## Hagbourne Hill - HarBUG Response to Development Proposals

The proposed Hagbourne Hill road developments directly affect existing, major cycle-commuter routes between Didcot and Harwell Campus. Please refer to appended map below.

### Effect of Proposed Developments on Existing Main Cycle-Commuter Routes

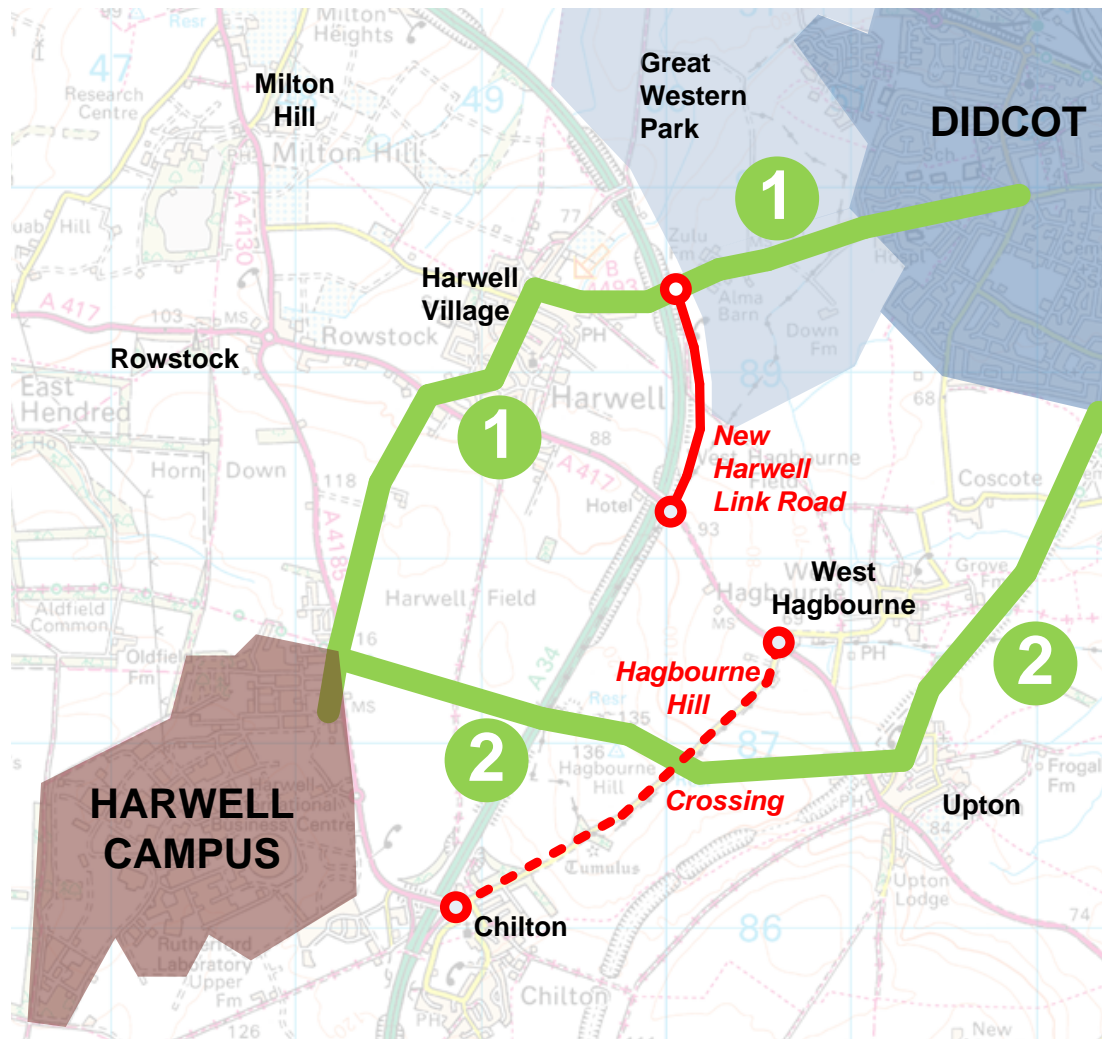
-  Relevant Main Cycle Commuter Routes:
-  1 Didcot to Harwell Campus via Winnaway
-  2 Didcot to Harwell Campus via Route 544
-  Proposed New & Improved Roads
